SUBJECT: ISSUANCE OF AMENDMENT NO. 19 TO FACILITY OPERATING LICENSE
NPF-38 - WATERFORD STEAM ELECTRIC STATION, UNIT 3
(TAC NOS. 64889, 64891 AND 64892)

AMENDMENT TO FACILITY OPERATING LICENSE

Amendment No. 19
License No. NPF-38

SAFETY EVALUATION BY THE OFFICE OF NUCLEAR REACTOR REGULATION
SUPPORTING AMENDMENT NO. 19 TO
FACILITY OPERATING LICENSE NO. NPF-38
LOUISIANA POWER AND LIGHT COMPANY
WATERFORD STEAM ELECTRIC STATION, UNIT 3
DOCKET NO. 50-382

FIGURE 3.1-1

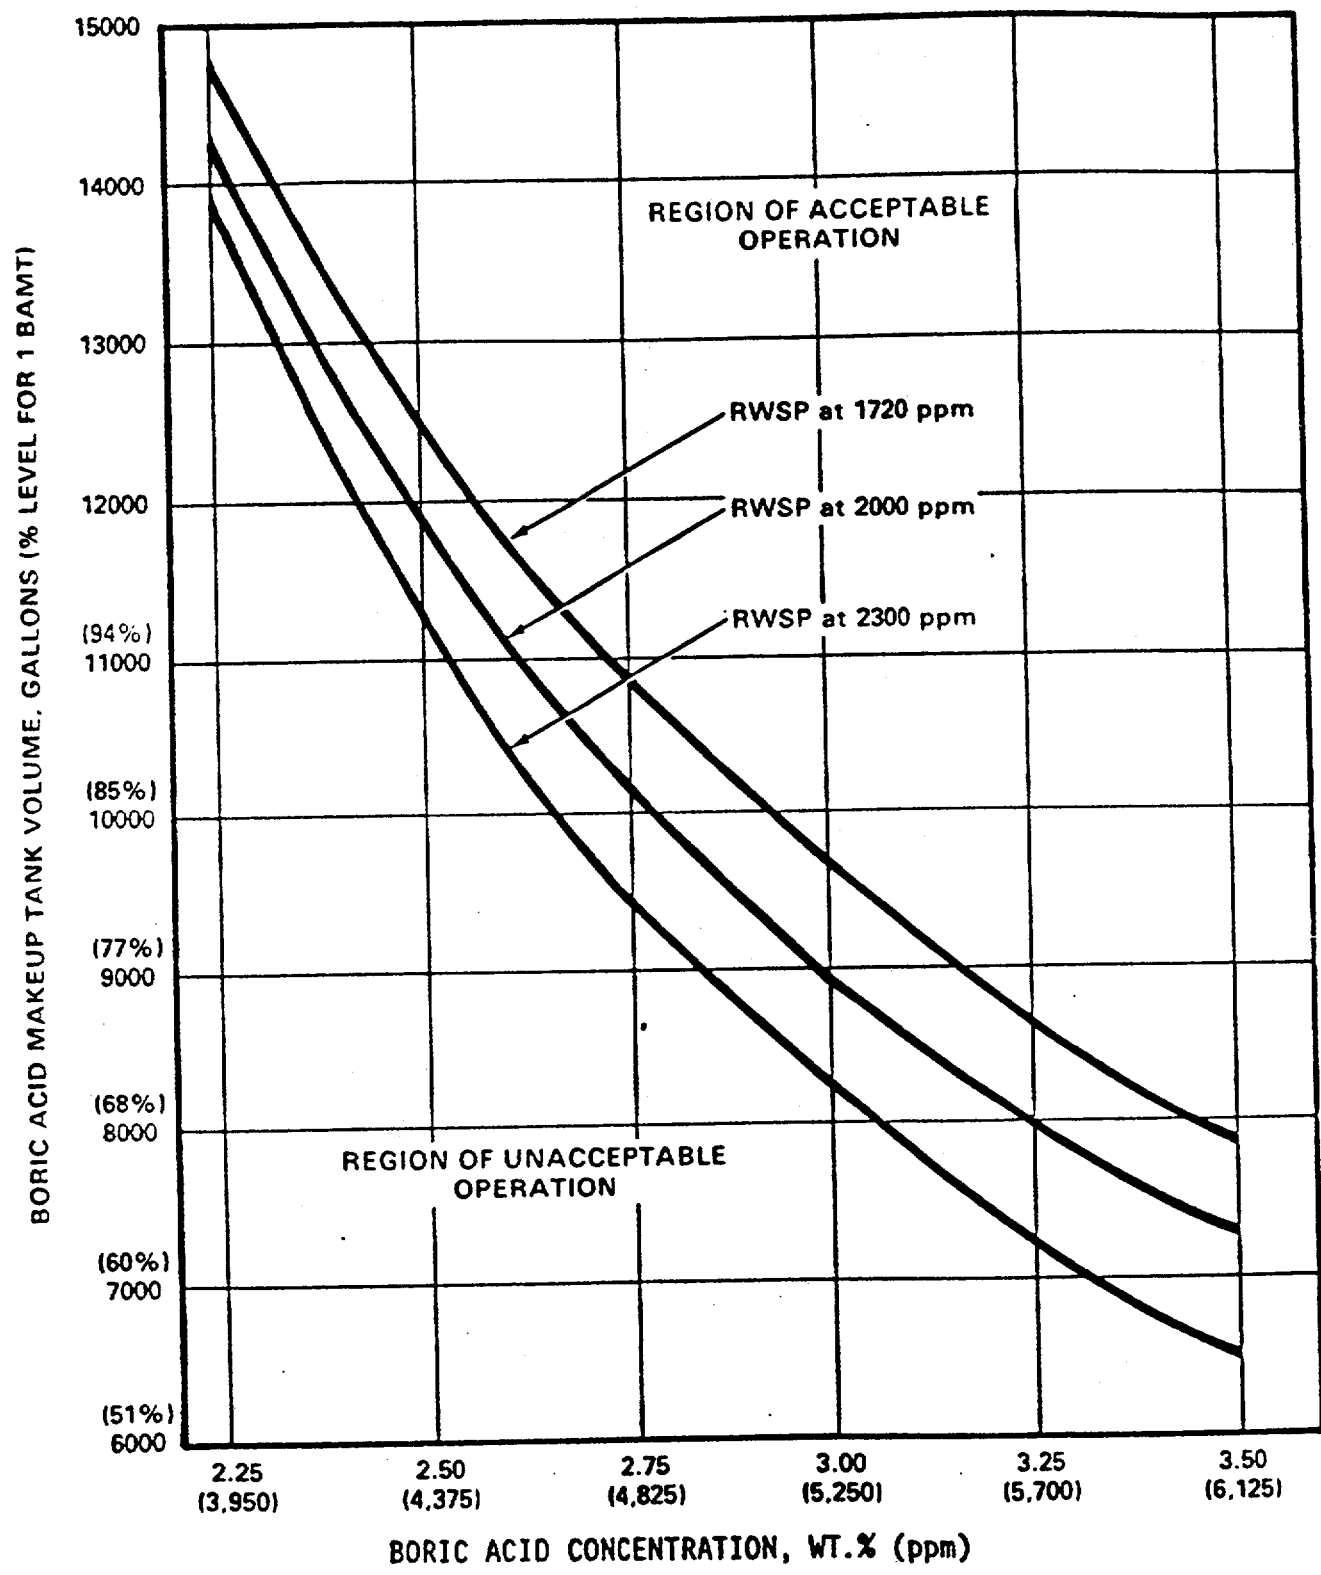
The proposed change would revise Technical Specifications 3.1.2.8b.1, "Borated Water Sources - Operating" and 3.5.4a, "Refueling Water Storage Pool". Currently, the Technical Specifications require that the Refueling Water Storage Pool (RWSP) contain a minimum water volume of 475,000 gallons. The Technical Specifications refer to 82% as being equal to the required volume; however, calculations have shown that, in order to maintain the required 475,000 gallons in the RWSP, the indicated level must be equal to 82.4%. The proposed change, would conservatively "round-up" the required level to 83% instead of rounding-off" to 82%.

- 3.1.2.8 Each of the following borated water sources shall be OPERABLE:
- a. At least one of the following sources:
 - 1) One boric acid makeup tank, with the tank contents in accordance with Figure 3.1-1, or
 - 2) Two boric acid makeup tanks, with the combined contents of the tanks in accordance with Figure 3.1-1, and
 - b. The refueling water storage pool with:
 1. A minimum contained borated water volume of 475,500 gallons (83% of indicated level), and
 2. A boron concentration of between 1720 and 2300 ppm of boron, and
 3. A solution temperature between 55°F and 100°F.
